MILPITAS PLANNING COMMISSION AGENDA REPORT

TITLE: "S" ZONE APPROVAL NO. SZ2003-7 AND USE PERMIT NO. UP2003-28

Proposal: A request for a commercial development consisting of 2 buildings (1 and 2 stories), associated site improvements, and a use permit for a parking reduction.

Location: 790 E. Capitol Avenue (APN 86-37-025)

SITE PLAN
 1ST. F. PLAN

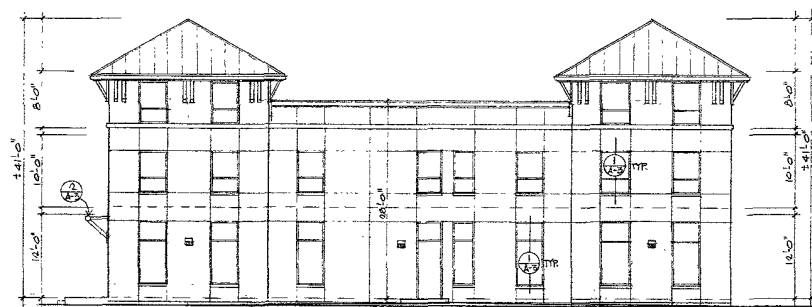
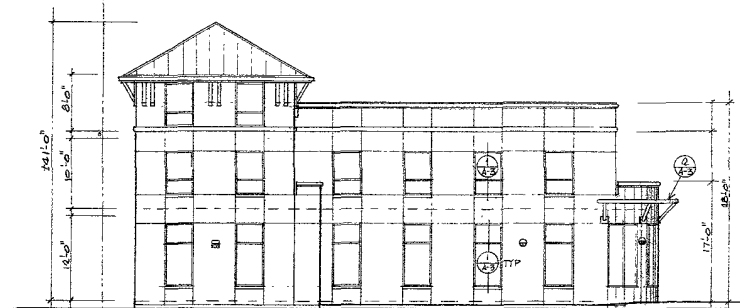
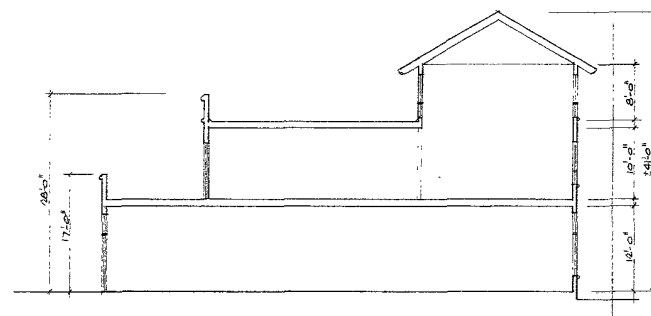
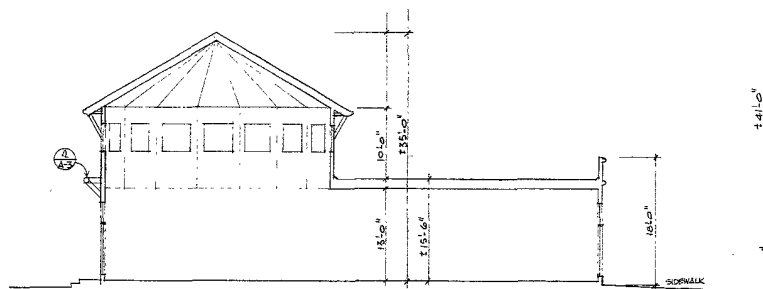
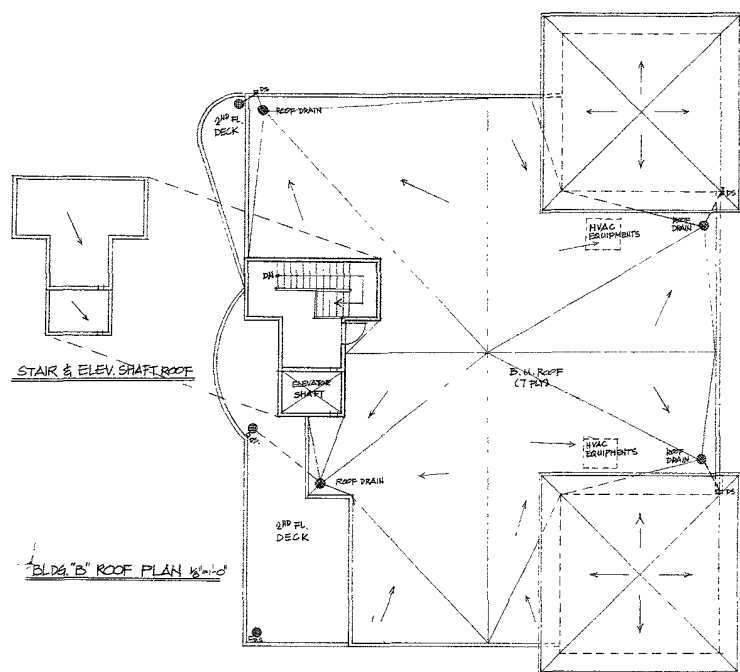
The Building Code requires handicap parking to be provided for each building. This requires 1 of the 2 handicap stalls to be relocated in front of Building A, which includes a 5-foot wide striped loading area. In addition, a parking stall distance of approximately 30 feet from the curb is needed in order to allow the queuing of vehicles onsite, which prevents the back-up of vehicles on East Capitol Avenue. In addition, space no. 15 cannot be maneuvered safely and must be omitted.

- a. Removal of parking stall nos. 15, 39 and 40 and the addition of a handicap stall with 5-foot wide loading area on parking stall no. 31 and 32; and
- b. Redesign area where stall nos. 15, 39 and 40 are located to screen parking from the street and provide a buffer (suggestions include extending landscape area and adding screening hedges for no.15 and create a landscape area with a shade tree and ornamental species to create a common outdoor area for nos. 39 and 40).

- 12) SITE PLAN. Prior to building permit issuance submitting revised site plans indicating the following:
- Removal of parking stall nos. 15, 39 and 40 and the addition of a handicap stall with 5-foot wide loading area on parking stall no. 31 and 32; and

- Redesign area where stall nos. 15, 39 and 40 are located to screen parking from street and provide a buffer (suggestions include extending landscape area and adding screening hedges for no.15 and create landscape area with shade tree and ornamental species to create a common outdoor area for nos. 39 and 40).

CAPITOL AVENUE ELEVATION 1/8" = 1'-0"

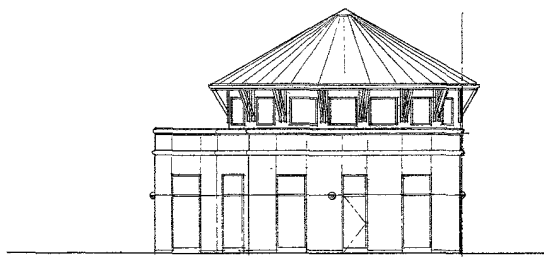
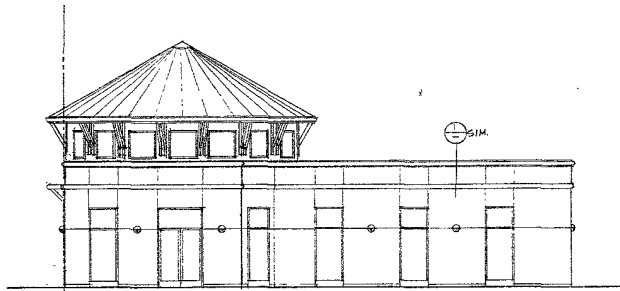
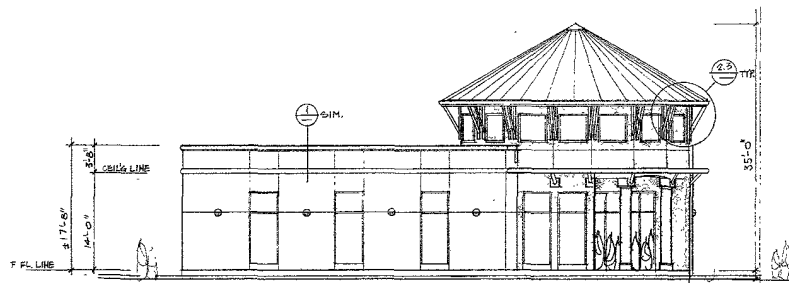
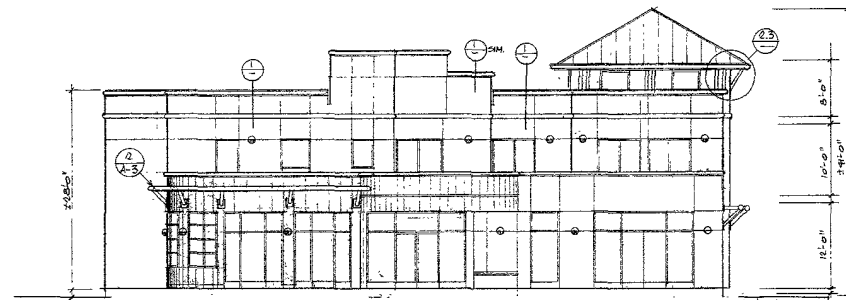
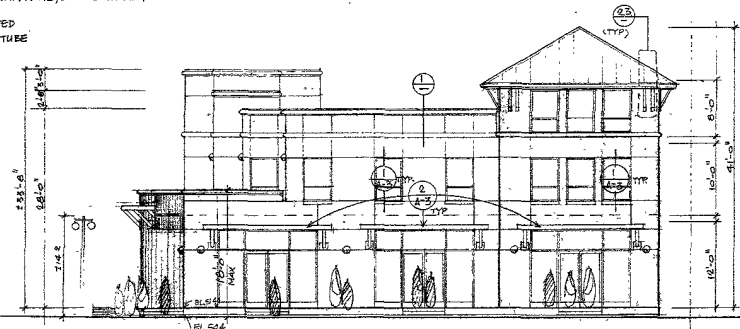
- a. Incorporating awnings on some of the south facing windows of the buildings to reduce overheating and glare;
- b. Provide details of columns used on the arcade at the entrance of Building A;
- c. Recess all windows a minimum of 4 inches; and
- d. Address bare wall on Building A facing East Capitol Avenue (perhaps add another window for more visibility of retail tenant or add a special feature or other adornment).

As noted on the elevations (Sheet A5) a 3'8" to 4' parapet would outline the top floors of the buildings with the exception of the tower elements, which have peaked roofs and the stepped roofline on Building B. The architect has stated 4 feet is sufficient height to conceal any type of mechanical equipment needed for the commercial tenants. *Staff recommends* a condition that no roof-top equipment shall exceed the height of the parapet or be visible from view.

- a. Incorporating awnings on some of the south facing windows of the buildings to reduce overheating and glare;
 - b. Provide details of columns used on the arcade at the entrance of Building A;

- c. Recess all windows a minimum of 4 inches; and
 - d. Address bare wall on Building A facing East Capitol Avenue (perhaps add another window for more visibility of retail tenant or add a special feature or other adornment).

LANDSCAPE PLAN
W/ EXTERIOR LIGHTING

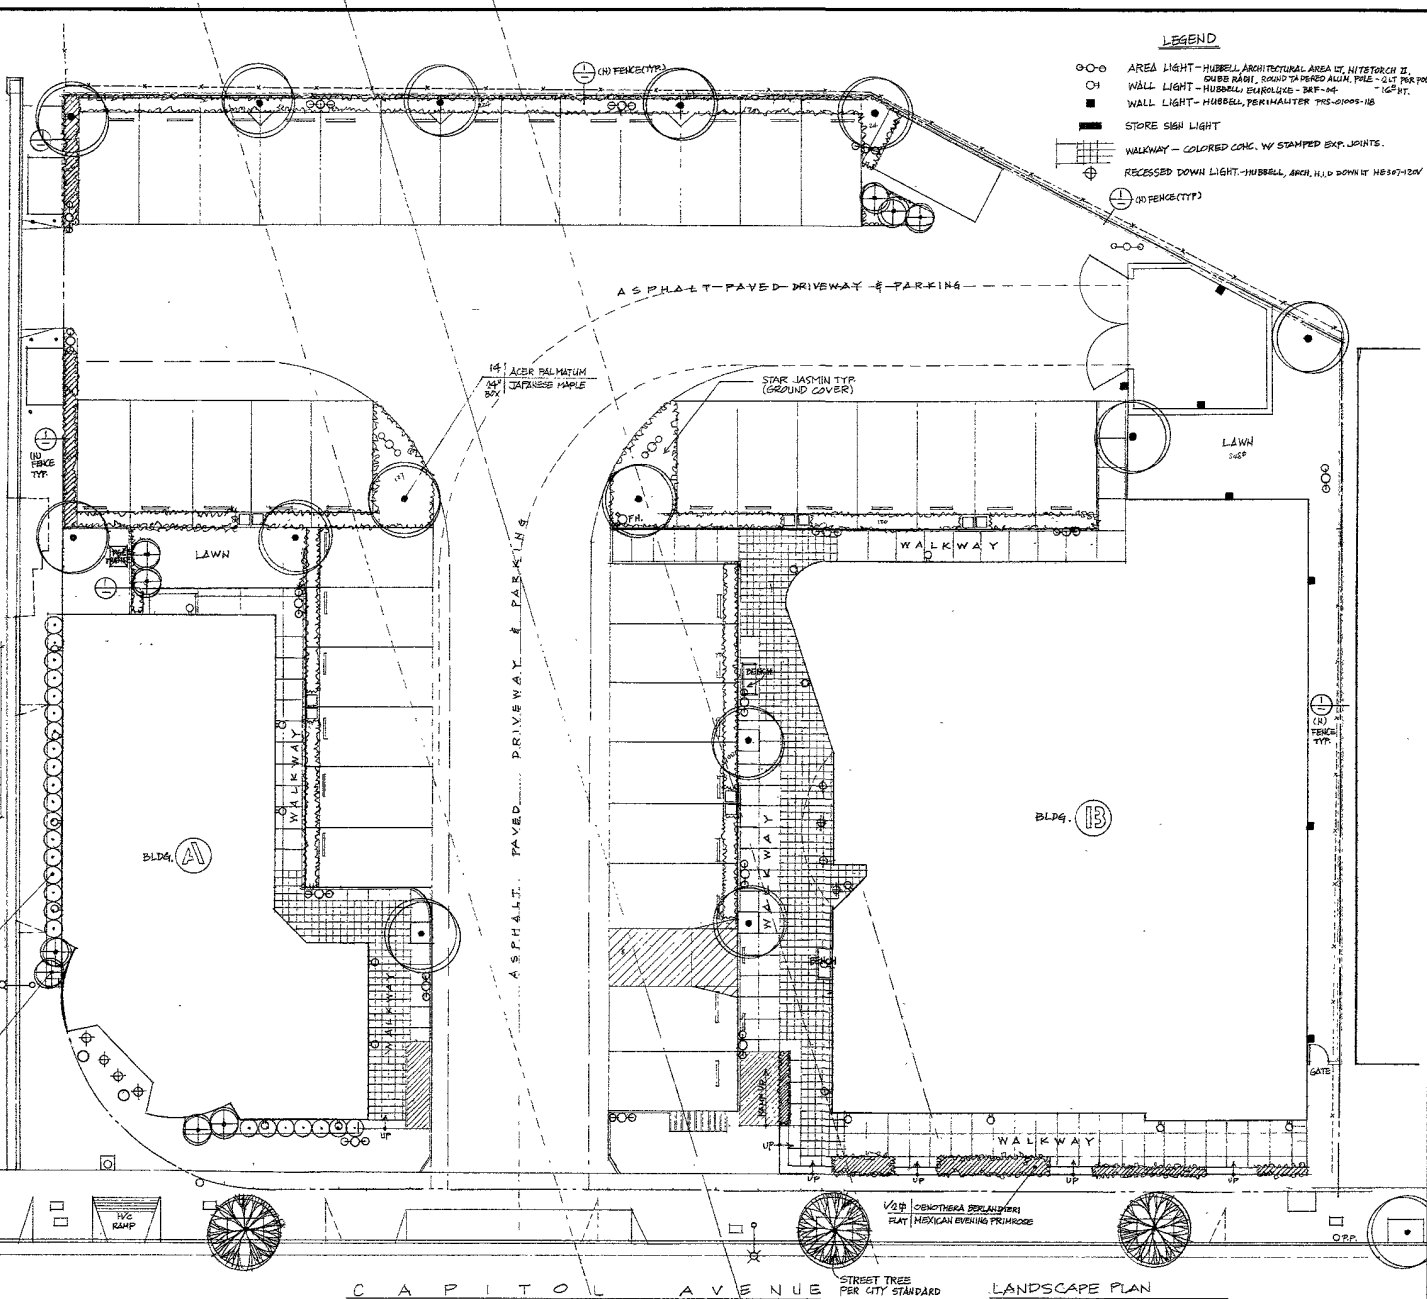
Staff recommends the following modifications to increase the variety of plant species, increase the tree canopy for shade in the parking lot and provide screening of trash enclosure from neighboring sites:

- a. Replace Japanese Maples with a larger canopy species and one that is not so delicate and sensitive to heat. Limited use of Japanese Maples as accent/ornamental species would be acceptable;
- b. Add shade trees in projecting parking diamonds, every third stall for parking areas along both buildings (similar to tree placement along south parking strip);
- c. Extend landscape area and incorporate screening plants where parking stall no. 15 is to be removed to screen parking lot from Lundy Place;
- d. Add shade tree to back lawn area and shrubs (perhaps Heavenly Bamboo) around base of trash enclosure;
- e. Add pavers or other traversable surface, between each parking space, to landscape areas that bisect walkways from parking areas facilitate pedestrian access between buildings and the parking lot;

- f. Replace Star Jasmine with another shrub variety (perhaps an ornamental or the camellias) to enhance the corner landscape planters (at interior hammerhead); and
- g. Submit an irrigation plan for the site.

- 13) IRRIGATION. Prior to building permit issuance, the applicant shall submit an irrigation plan for all landscape areas. (P)
- 14) LANDSCAPE. Prior to building permit issuance, the applicant shall submit a revised landscape & streetscape plan that includes the following:

- Replace Japanese Maples with a larger canopy species and one that is not so delicate and sensitive to heat. Limited use of Japanese Maples as accent/ornamental species would be acceptable;

- Add shade trees in projecting parking diamonds, every third stall for parking areas along both buildings (similar to tree placement along south parking strip);

- Extend landscape area and incorporate screening plants where parking stall no. 15 is to be removed to screen parking lot from Lundy Place;
 - Add shade tree to back lawn area and shrubs (perhaps Heavenly Bamboo) around base of trash enclosure;

- Add pavers or other traversable surface, between each parking space to landscape areas that bisect walkway from parking areas to facilitate pedestrian access between buildings and the parking lot; and

- Replace Star Jasmine with another shrub variety (perhaps an ornamental or the camellias) to enhance the corner landscape planters (at interior hammerhead).
